Appeal NO: ABP 322154-25

Observation from Con Sheehan

Re: Bord Pleanála Case reference: PL10.322154

Applicant: Briskalagh Limited.

Map 1

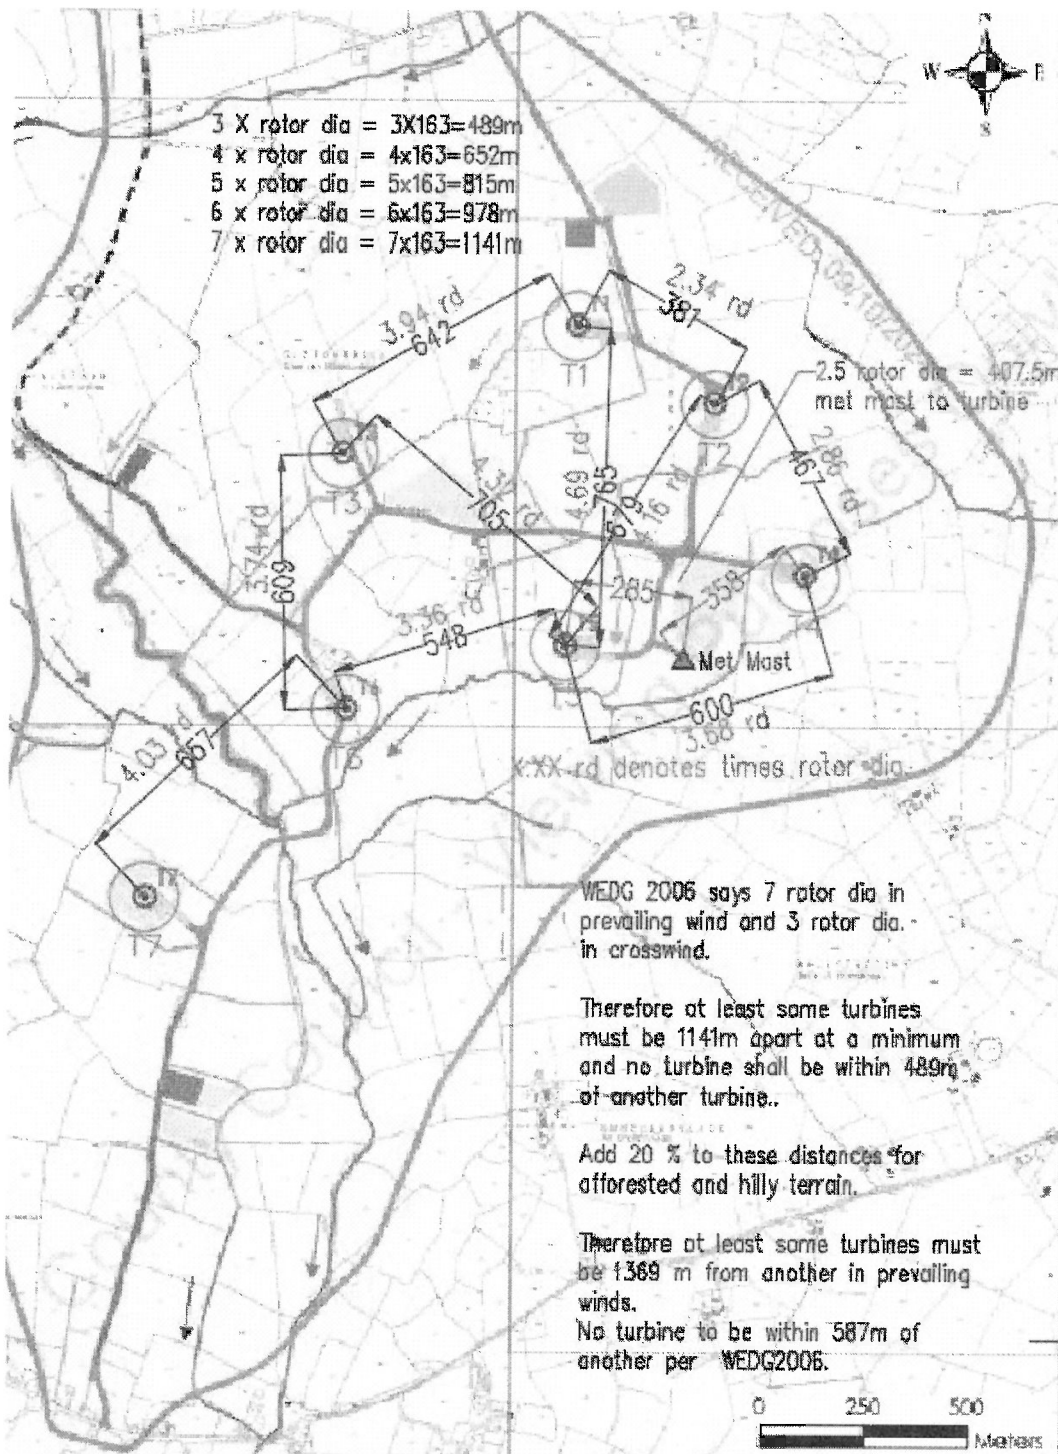
Planning reference 25/60003, to which this observation refers, has, as one can see in Map 1 (next page), completely ignored the turbine separation distances from adjacent turbines. Also note the location of the Met mast which I believe to be in a very poor location for the purpose it is intended. Turbulence from the adjacent turbines will make it ineffective. The recommended spacing from a met mast to a turbine is 2.5 rotor diameters.

Of the windfarms I have been involved in to date, those WEDG 2006 guidelines on turbine separation distances from adjacent turbines have not been complied with, as is the case here.

1: The manufacturer's specifications for the particular model of turbines used in their design (the Nordex N163 STE) with specific reference to the minimum separation distances from turbine to turbine within the windfarm (not windfarm to windfarm). This should also be shown on a dedicated plan and the rotor diameters between turbines given similar to Map 1 on page 3 of this observation.

It is my opinion that the developers will not get a valid warranty for the eventual turbine, after their tender process, for a spacing less than 5 rotor diameters in the prevailing wind direction and 3 rotor diameters in other directions. The layout on Map 1 shows a significant lack of spacing, if this is the case.
